Technical change to MHP 100 A male crimp contacts

PCN-number: PKDPB72-20180905-00-A
date of publishing: 05.09.2018
duration of validity: 04.09.2019
revision number: A

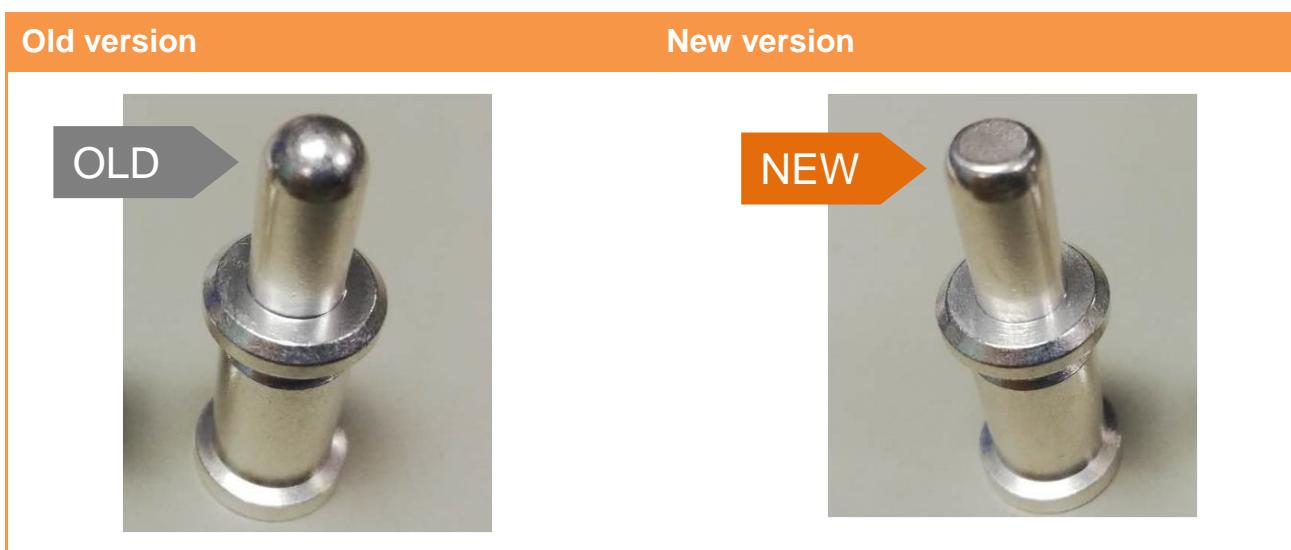
The male crimp contacts of ModuPlug MHP 100A series were produced with a rounded head.

Changing the contact head from round to flat.

The reason for change is an optimization of the production process.
